# **“IMPORTANT SAFETY RECALL NOTICE”**

### **RECALL NO: 16V-005**

#### **Attention Trans Tech Bus Dealer:**

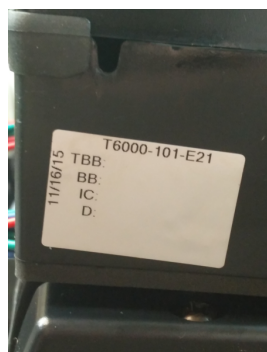
The defect involves Federal Motor Vehicle Safety Standard No. 571.131; *“School Bus Pedestrian Safety Devices”*. Specifically, the adhesive and process used to bond the reflective stop decal to the stop arm body/housing was improperly performed, which can lead to delamination and/or detachment during operation.

Inspection for this recall may be performed by viewing the underside of the stop arm (pictured below) and reviewing the information printed on the white label (which includes date of manufacture and model).

If your Stop Arm model is any of the T6000-, T6100-, or T7000- and manufacture dates are in the period between May 1, 2015 and Oct 19, 2015, then you are affected.

Replacing the stop arm blade assemblies will resolve the defect (application of the decal to the blade in the field is not recommended). The free service kit provided by SMI will include (1) Transpec stop arm blade (replacement part will be based on the stop arm part number,) and detailed work instructions. It is the responsibility of the end-user to inspect for and mitigate the remedy.
